DATE: July 11, 2012

TO: All Prospective Bidders

SUBJECT: Addendum No. 2
 US 50 HOV Lanes Phase 0 El Dorado Hills Interchange
 Project
 Contract No. PW 12-30639, CIP No. 53124

NO SCALE **X-3**

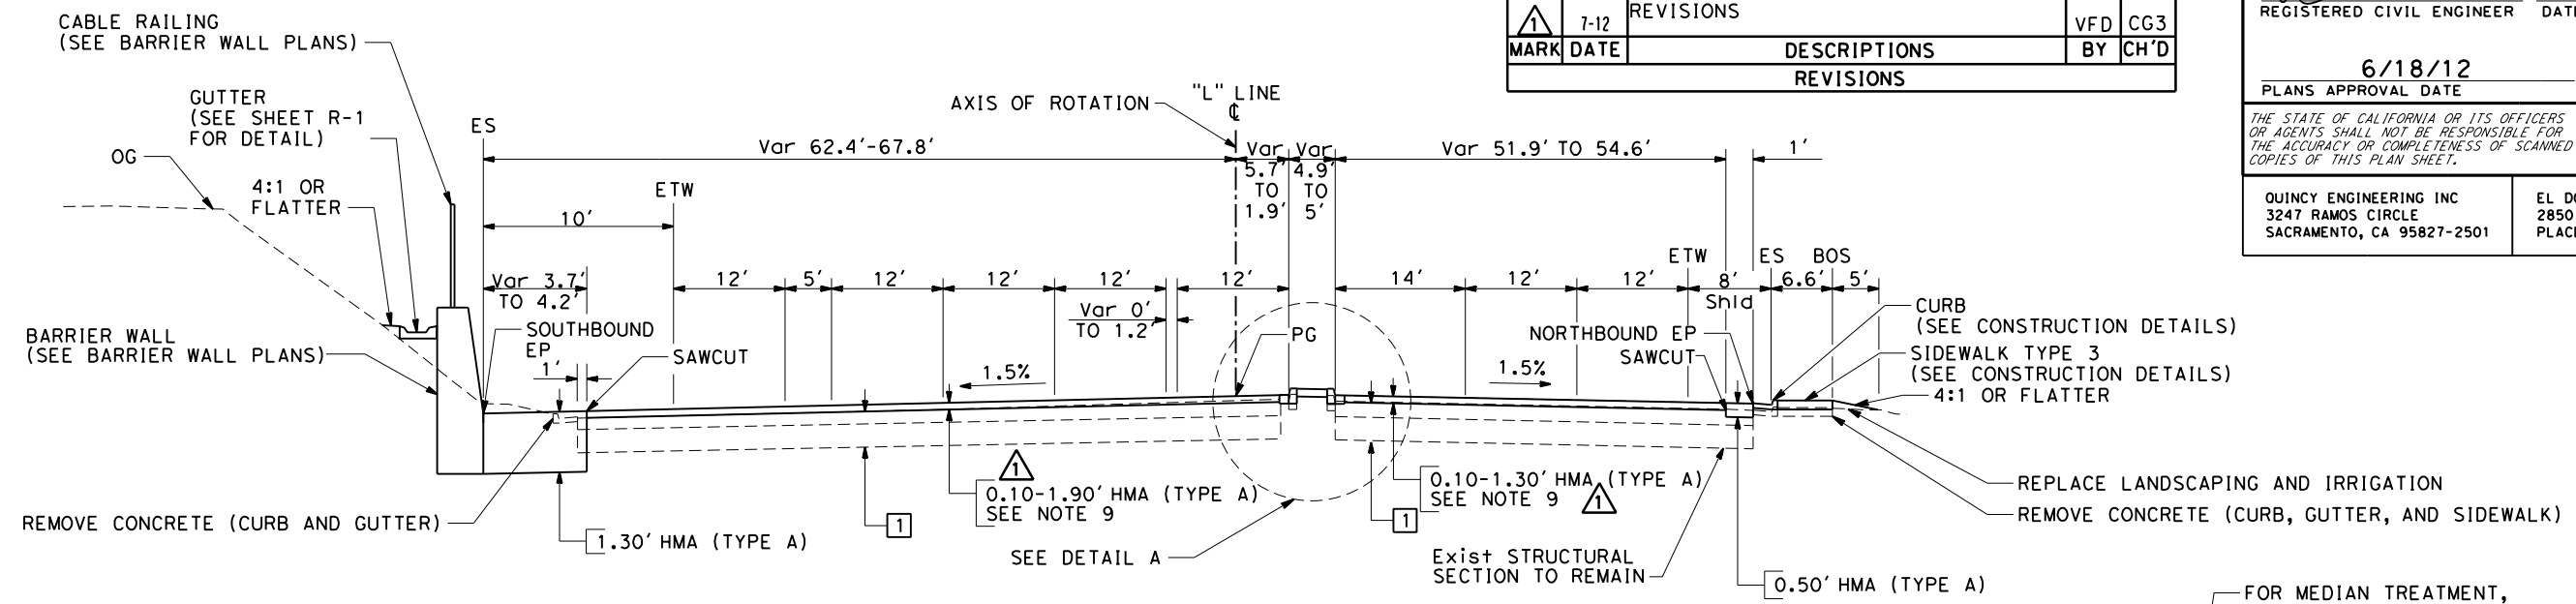
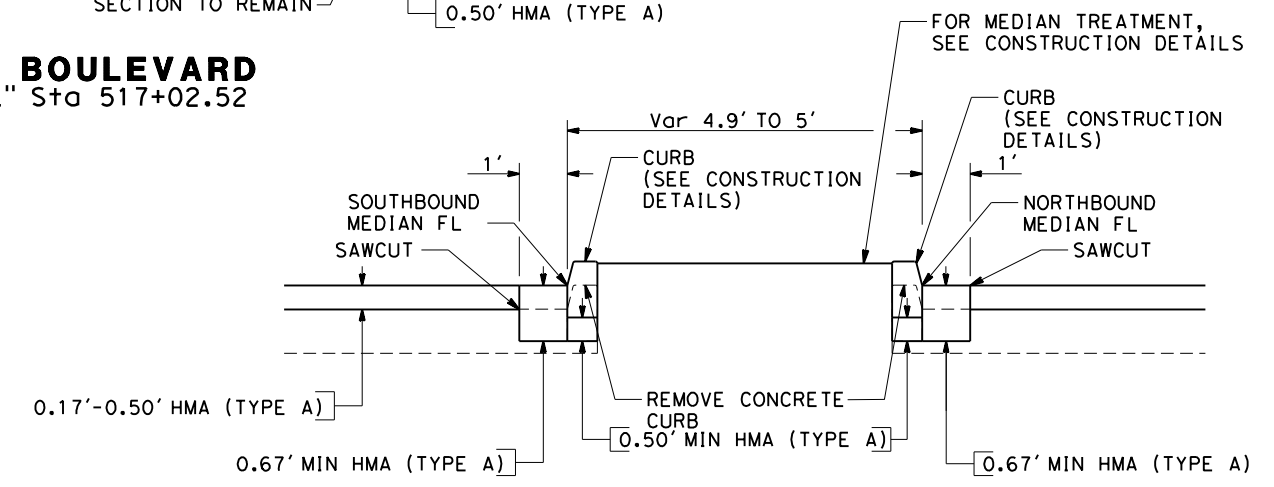
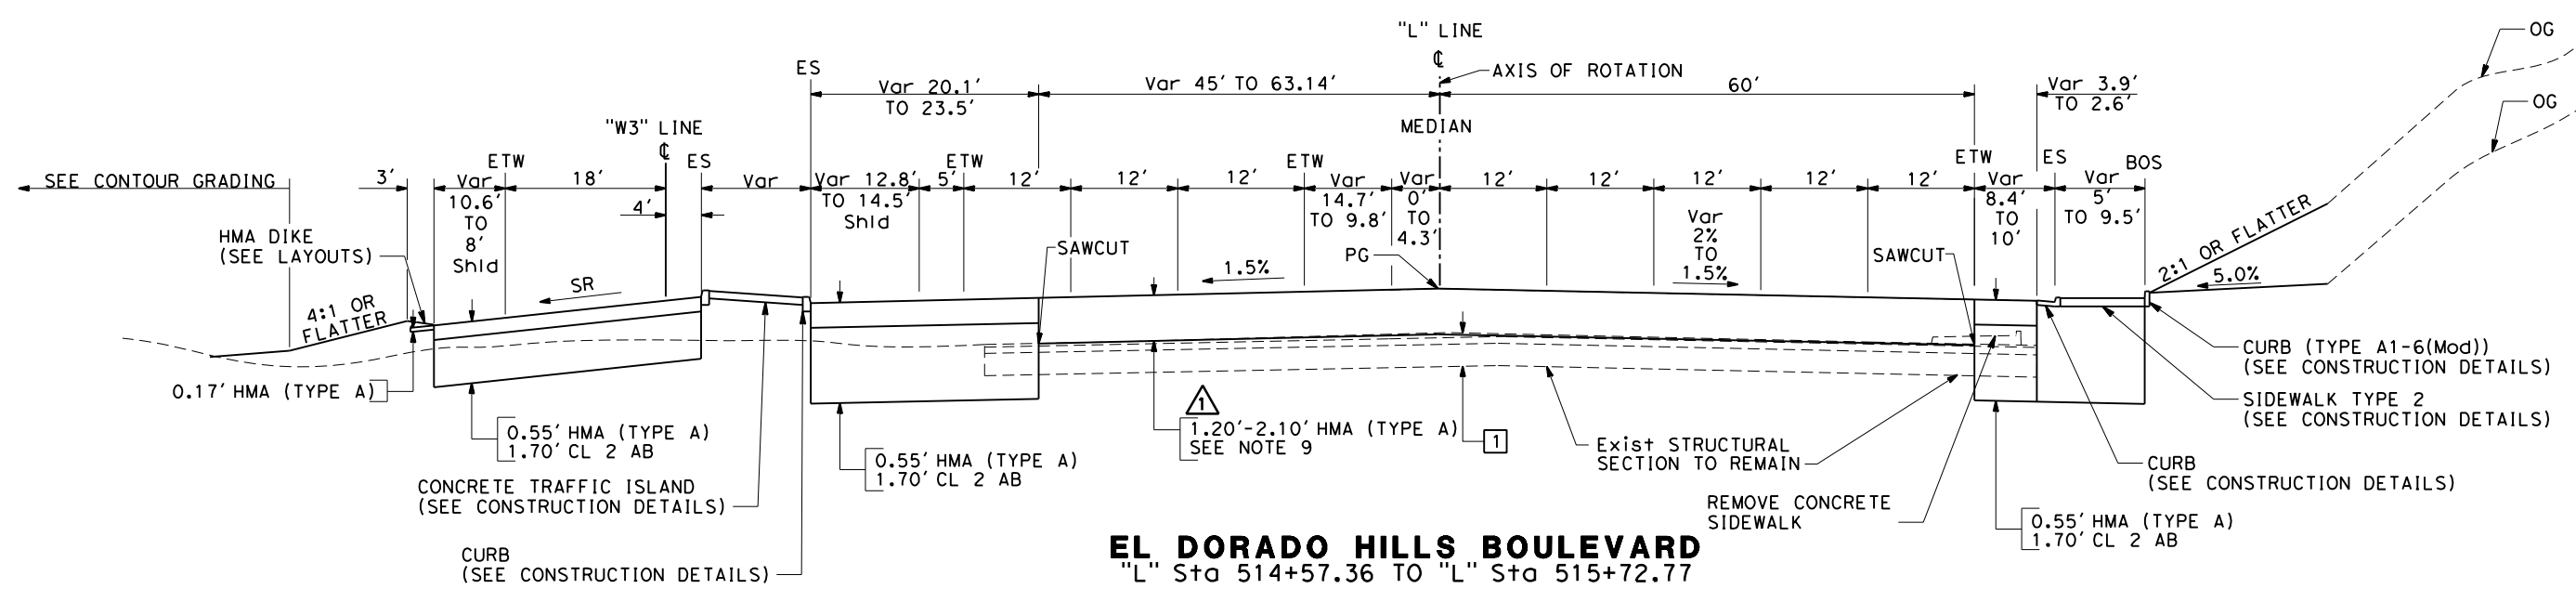
HOT MIX ASPHALT (DEEP LIFT) REVISIONS			
MARK	DATE	DESCRIPTIONS	BY CH'D
1	7-12		VFD CG3

X-4

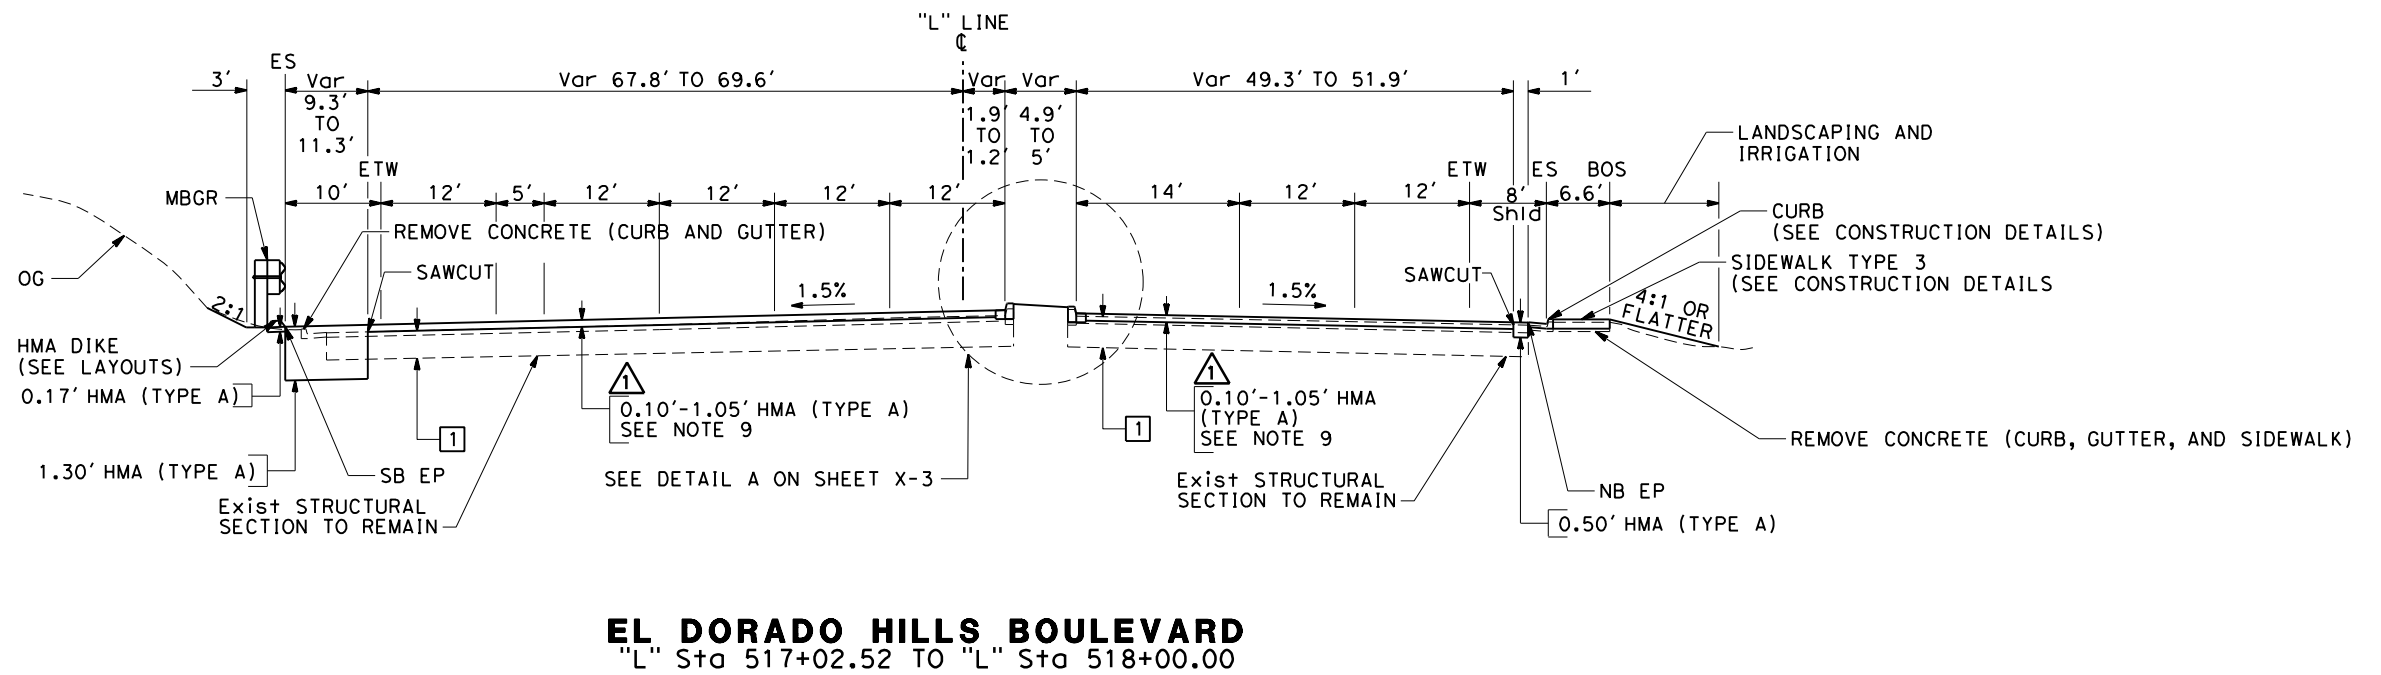
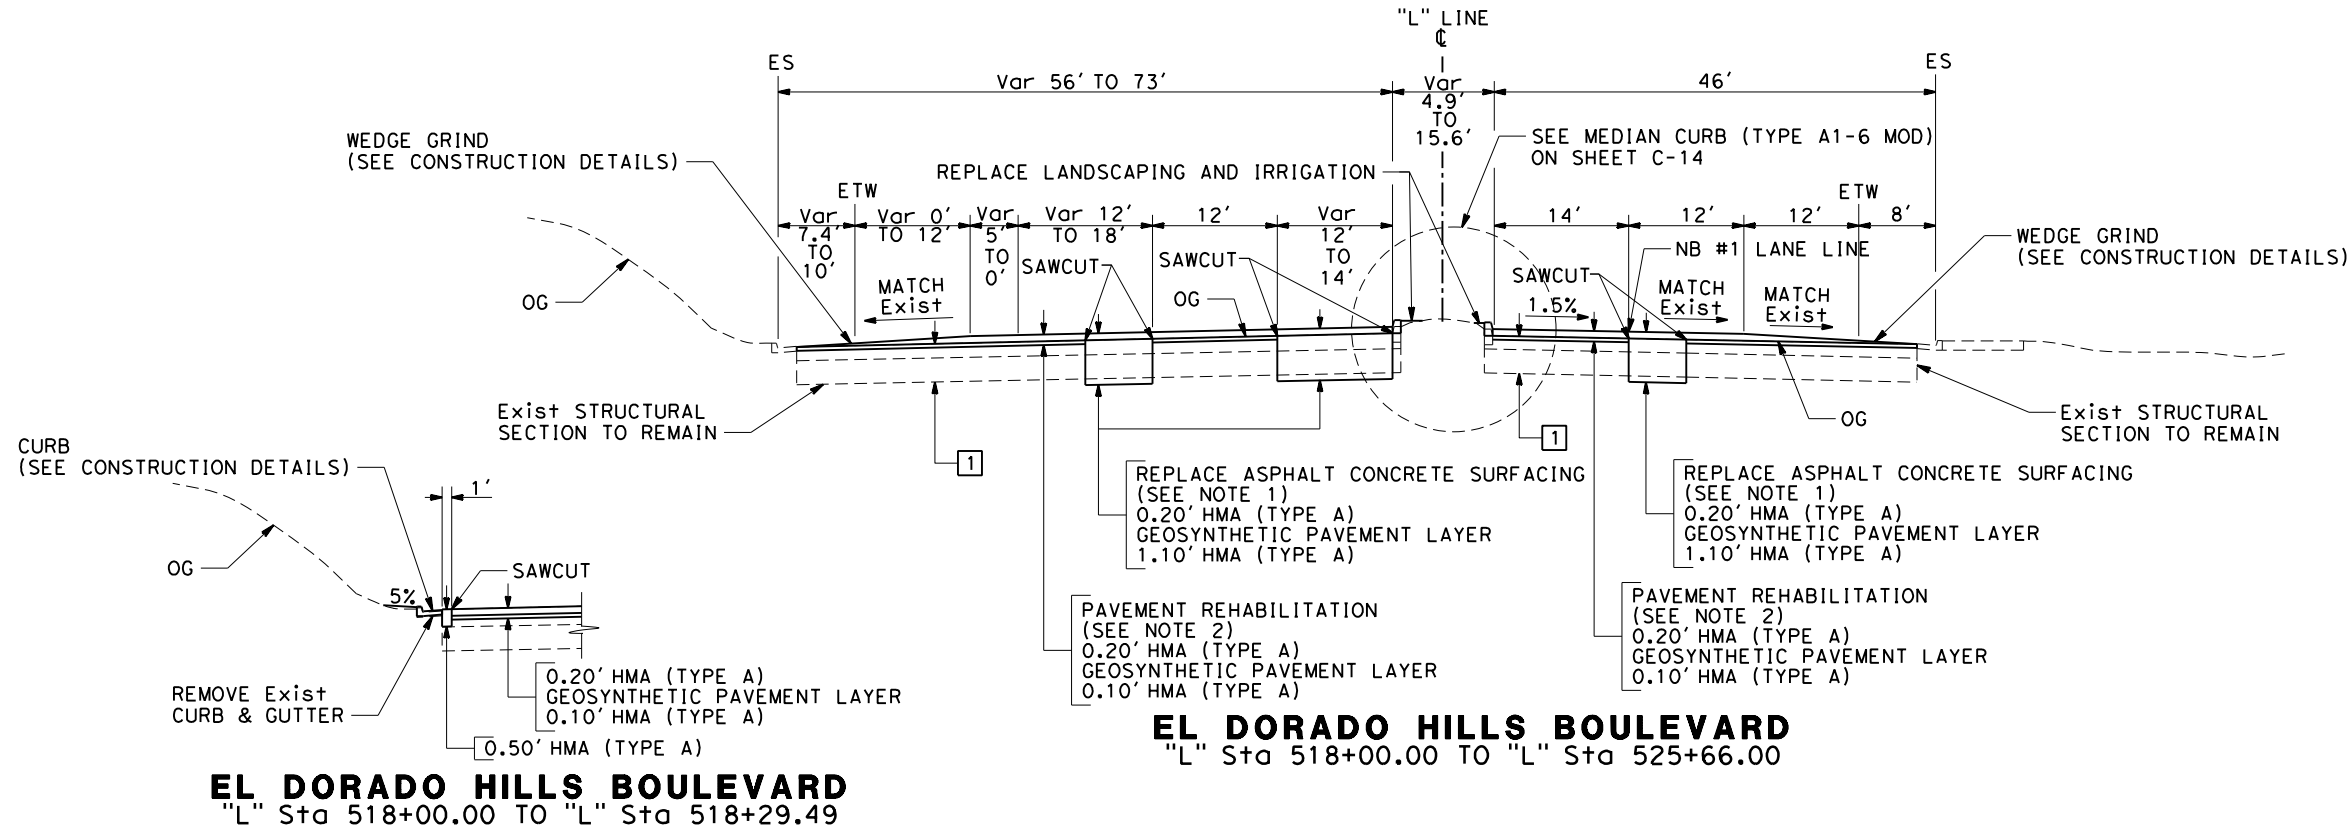
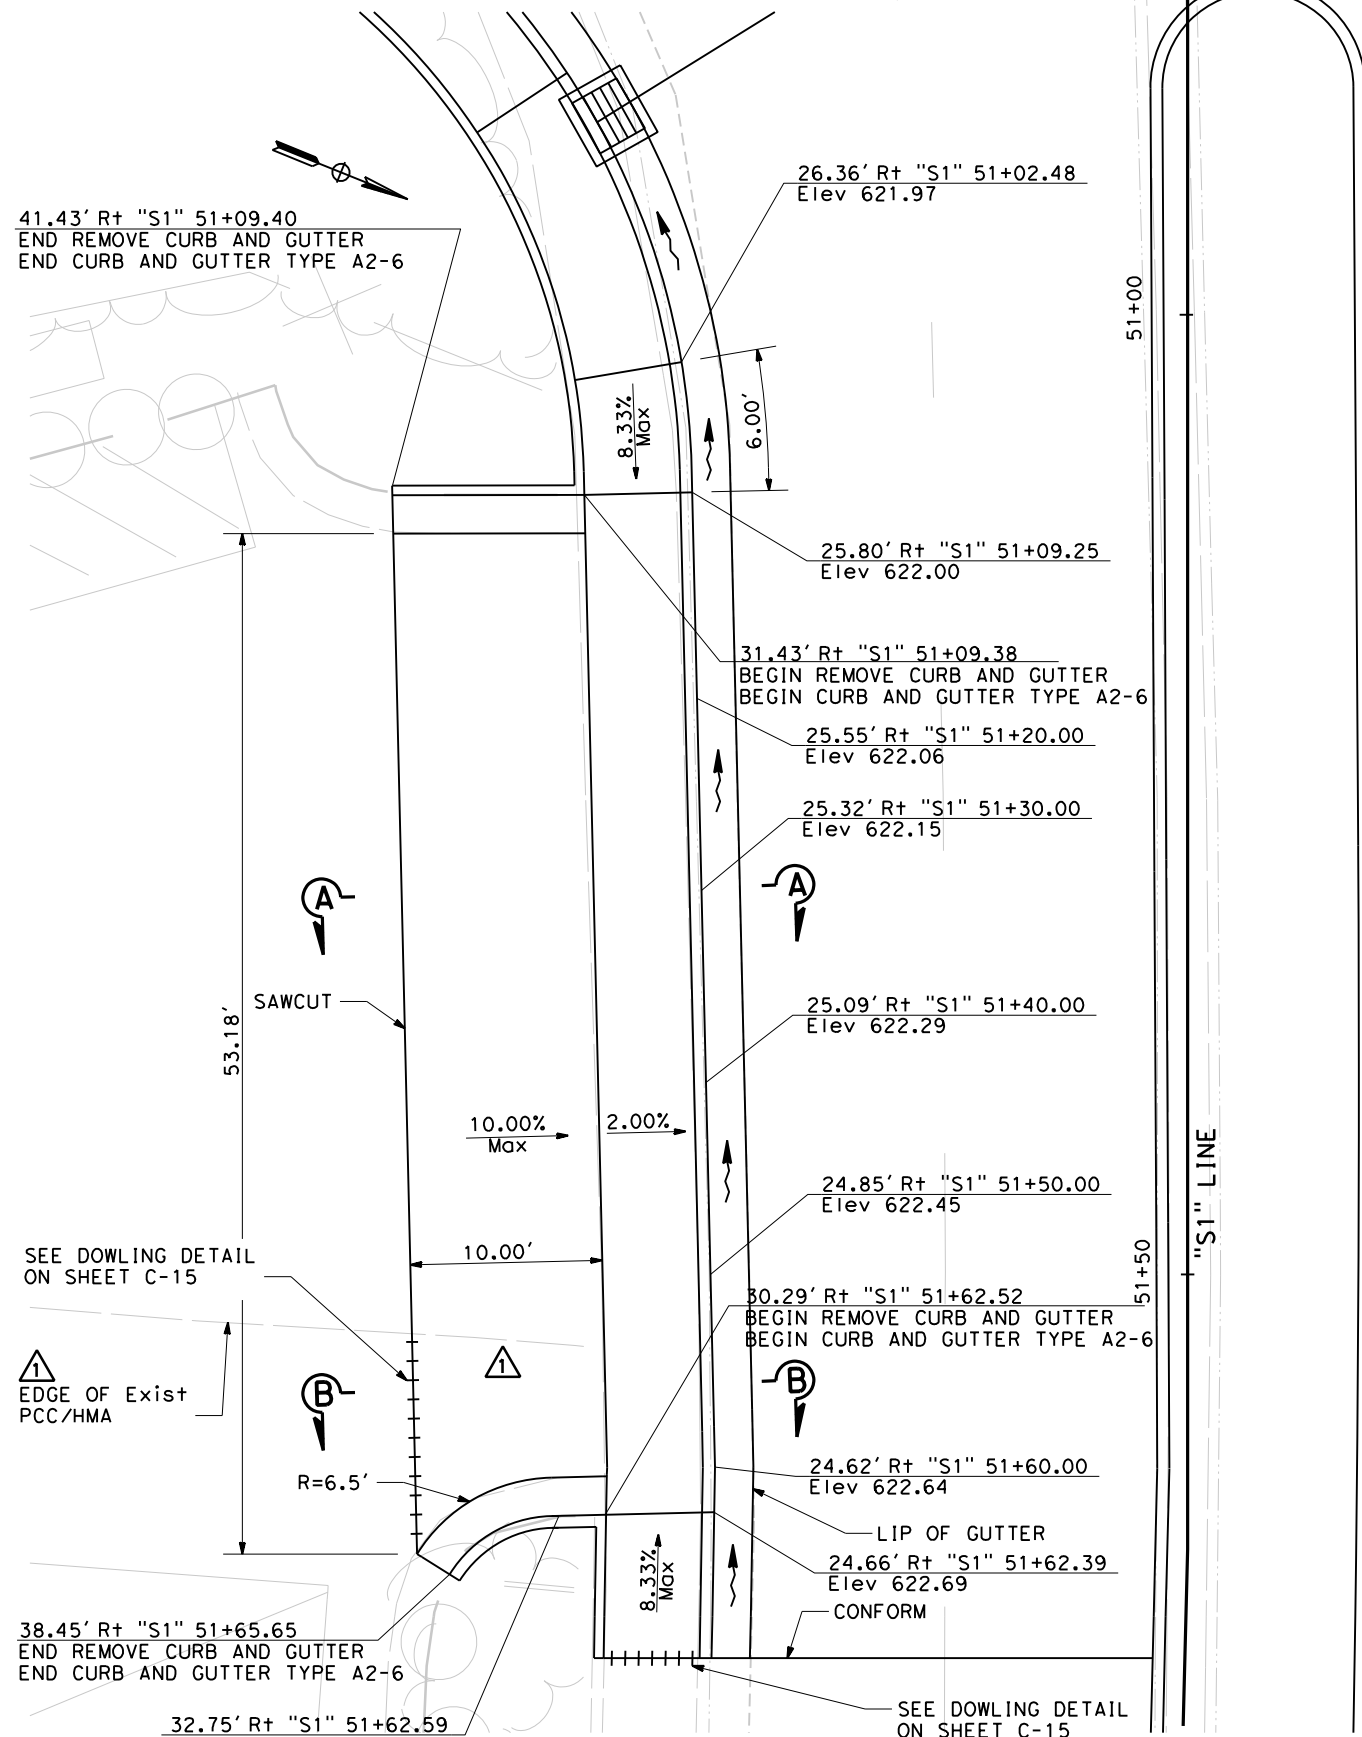
7-12	HOT MIX ASPHALT (DEEP LIFT) REVISIONS	VFD	CG3
MARK	DATE	DESCRIPTIONS	BY
		REVISIONS	CH'D

C-3

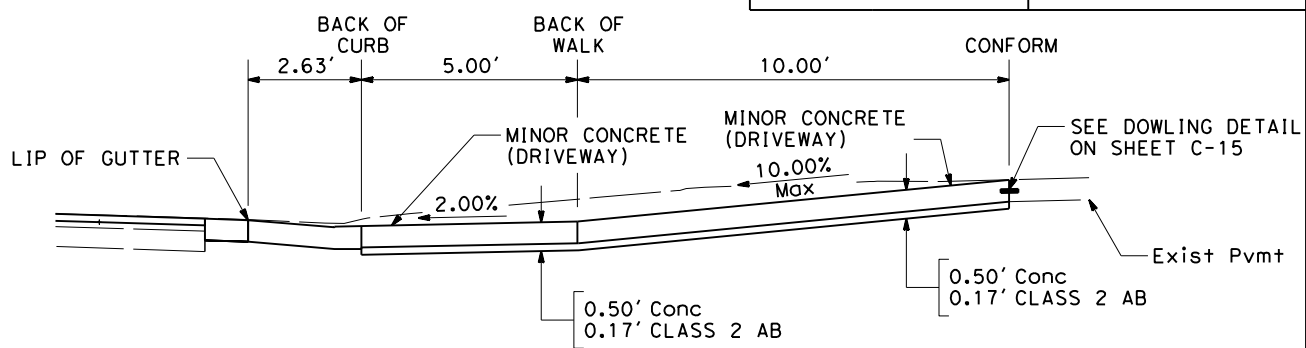
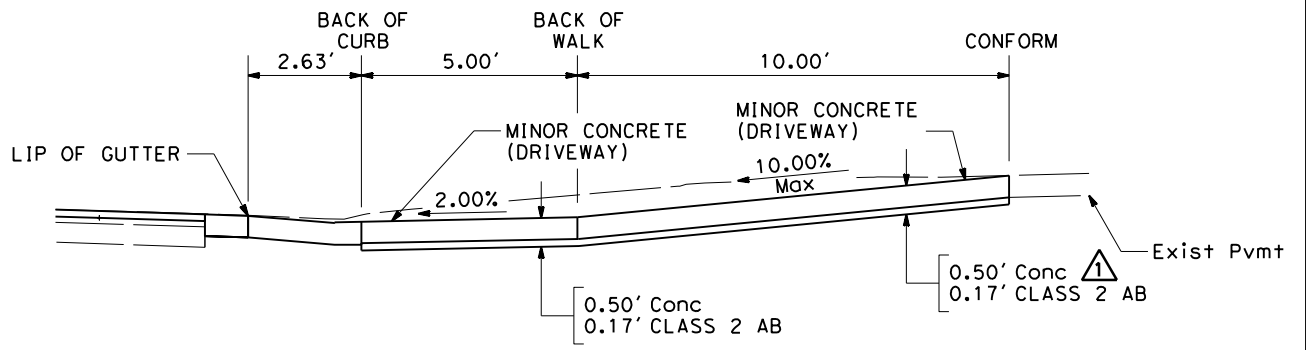
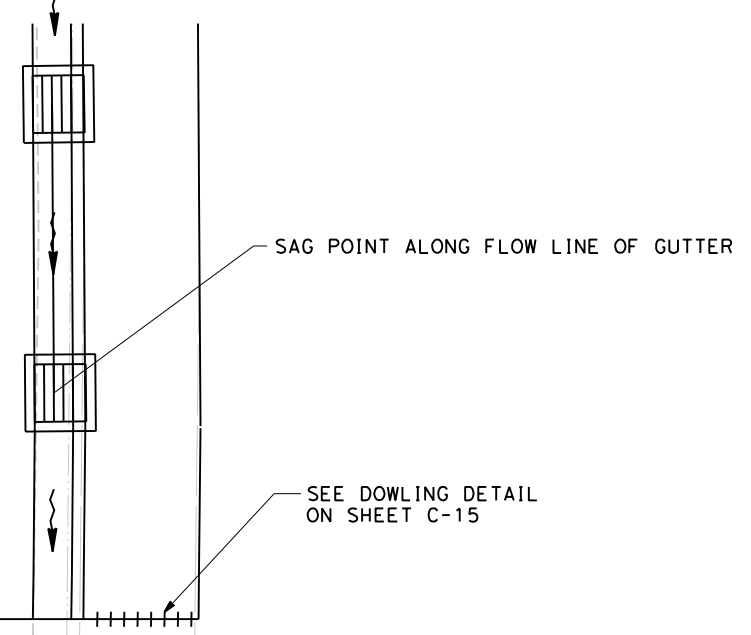
MARK	DATE	DESCRIPTIONS	BY	CH'D
7-12		MINOR CONCRETE (DRIVEWAY) REVISION	VFD	CG3
REVISIONS
